<b>Project</b>	<b>IEEE 802.16 Broadband Wireless Access Working Group</b> < <a href="http://ieee802.org/16">http://ieee802.org/16</a> >	
<b>Title</b>	<b>Security Context Transfer for Handoffs</b>	
<b>Date Submitted</b>	<b>2005-09-12</b>	
<b>Source(s)</b>	Mi-Young Yun	<a href="mailto:myyun@etri.re.kr">myyun@etri.re.kr</a>
	Jung Mo Moon, PhD	<a href="mailto:jmmoon@etri.re.kr">jmmoon@etri.re.kr</a>
	Jaesun Cha	<a href="mailto:jscha@etri.re.kr">jscha@etri.re.kr</a>
	Sang Ho Lee, PhD	<a href="mailto:leesh@etri.re.kr">leesh@etri.re.kr</a>
	ETRI	
	161, Gajeong-dong, Yuseong-gu,	Voice: 82-42-860-4821
	Daejeon, 305-700, Korea	Fax: 82-42-861-1966
<b>Re:</b>	Contribution on comments to IEEE 802.16g-05/008	
<b>Abstract</b>	We define context transfer primitives for security information through the NCMS entity and describe the security information needed by a target BS. This proposal makes it possible to perform the authentication after handoffs as specified in the remainder of this document.

# Security Context Transfer for Handoffs

Figure 1. Context transfer primitives initiated by a serving BS

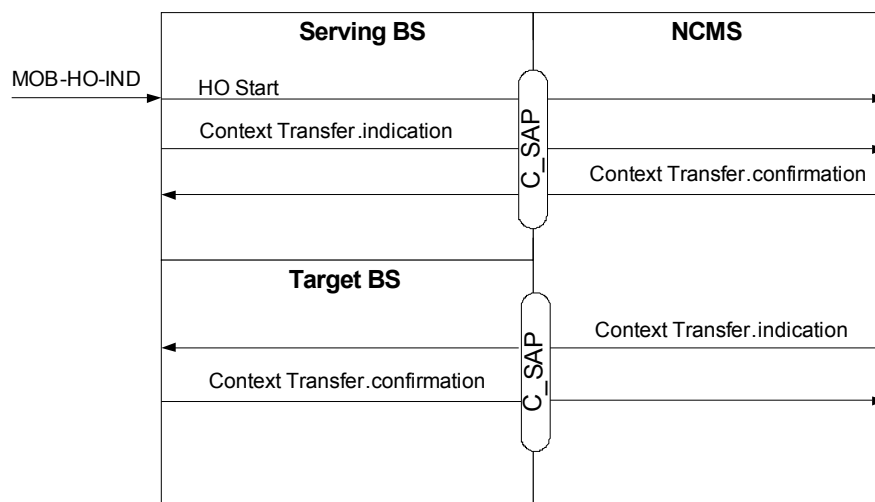
[Insert section 14.5.5.4 as follow]

#### 14.5.5.4 Security for Handoffs

In the handover procedure, if an MS tries to process the network re-entry to a target BS, but the target BS has not an MS information, then the target BS may request the MS information to a serving BS and the serving BS may give a response of it.

Figure 1 shows the context transfer primitives initiated by a serving BS between a BS and an NCMS entity.
